UNIVERSITY OF MARYLAND

SUBJECT: UNIVERSITY OF MARYLAND – REQUEST FOR ADDITIONAL
INFORMATION RE: REVIEW OF THE ARGON-41 RADIOLOGICAL DOSE
ASSESSMENT FOR LICENSE RENEWAL OF THE MARYLAND UNIVERSITY
TRAINING REACTOR (TAC NO. ME1592) LICENSE NO. 70; DOCKET NO. 50-166

Enclosed please find the response to the RAI dated September 25, 2014 for the University of
Maryland Training Reactor (MUTR), License No. R-70; Docket No. 50-166, regarding the
radiological dose assessment from Ar-41.

Figure 1. Baltimore-Washington Region Wind Rose [1954-2009]

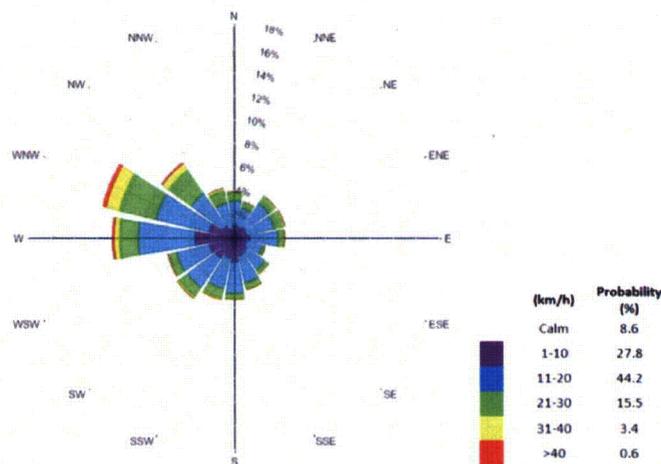
Provide the leakage flow rate of Ar-41 from the restricted area to any outlying areas (hallways, classrooms, etc) and the environment. Provide any calculations, assumptions, and/or conservatism used to support the flow rate determination.

Although building conditions and measurements indicate air flows from the unrestricted building hall ways into the MUTR and out the rollup door, the condition in which a North wind hits the roll up door, resulting in air flow into the MUTR and then into subsequent unrestricted hall ways was evaluated. In order to determine both the probability and magnitude of a North wind, blowing against the MUTR exterior roll-up door, a wind rose of the directional wind distribution in the Baltimore-Washington region during the period of 1954 to 2009 was consulted. See Figure 1. A weighted average of the wind speed blowing from the North-North-West, North and North-North-East found that during 10% of the year, an average wind of 1.6 miles per hour (MPH) will come from the northerly direction. Table 2 provides leakage flow rates under these conditions.

Figure 1. MUTR 1st floor

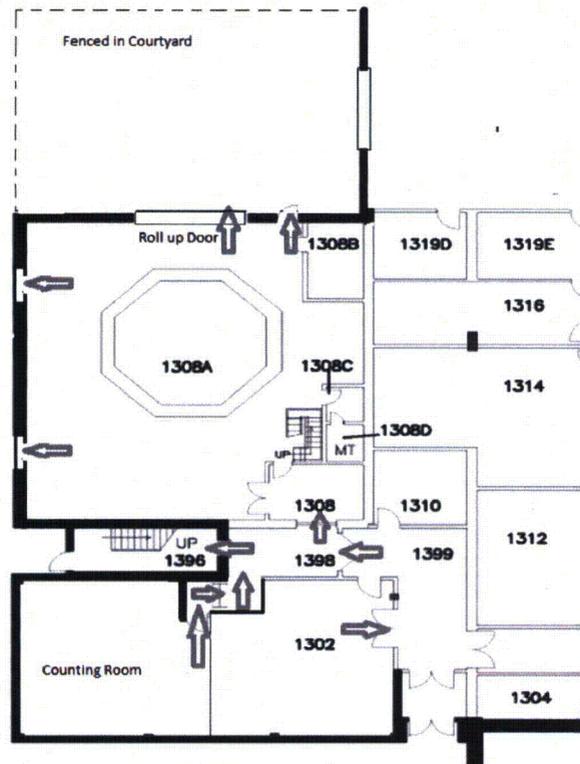
Provide a description of the release point(s) and any flow paths for the Ar-41 effluent from the restricted area to any unrestricted area(s).

The MUTR floor plans, Fig.1 bottom [experimental] floor and Fig.2 the upper [balcony] floor, are annotated with arrows depicting direction of airflow. The flow directions were determined by measurement with an airflow velocity meter and gap analysis of all penetrations of the reactor building and adjacent building. Note the Figure 2 also includes a n overlay to depict the reactor penthouse and its louver locations. As described in the previous section, the wind rose shows that 10% of the year, a northerly wind has the potential to reverse the flow direction. Under these conditions the greatest leakage will be from room 1308 to hallway 1398.
